## DEVIATION REQUEST AND DECISION FORM

Project Name :	CLOVERLEAF SUBDIVISION
Schedule No.(s) :	7124202236, 7124202237, 7123102041, 7123102044
Legal Description :	SEE ATTACHED – Exhibit C

# Deviation Request 2\_V1\_redlines.pdf Markup Summary

WALTERS POINT CROSS SECTION  
CLOVERLEAF  
JOB NO. 25158.01  
05/28/2020  
SHEET 1 OF 1

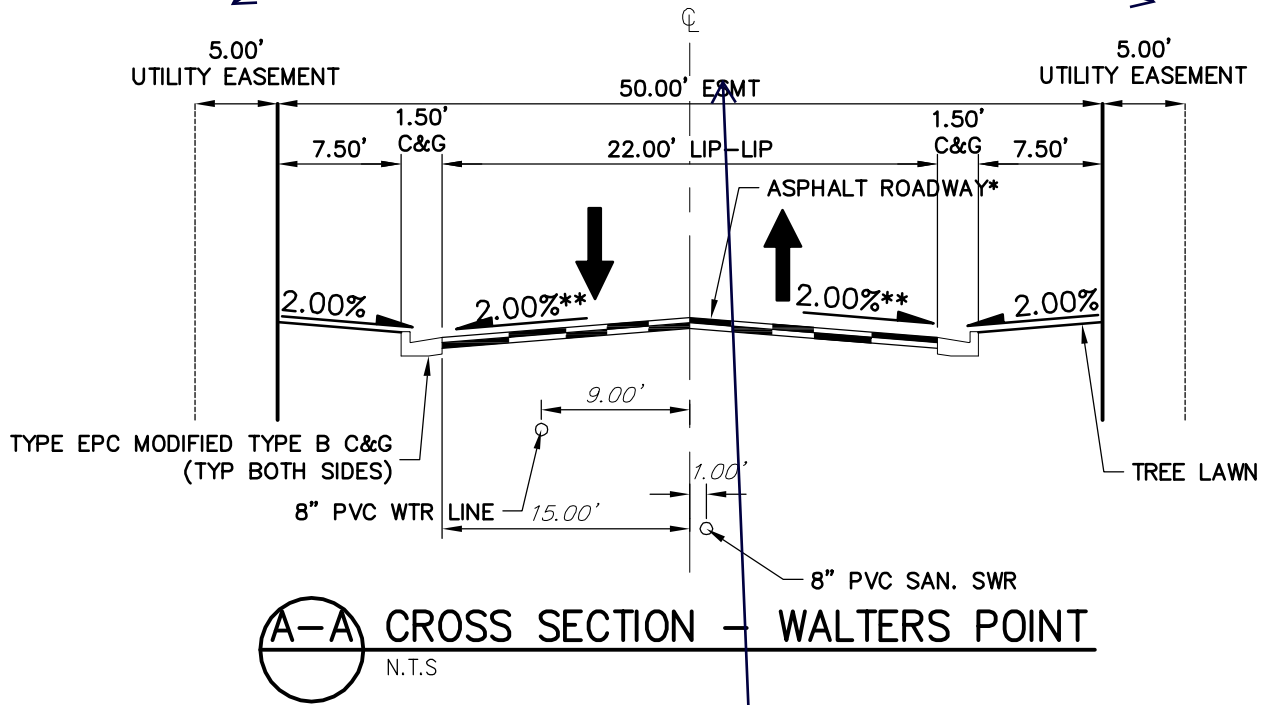
Identify the North and South side.

Locate road within a tract.
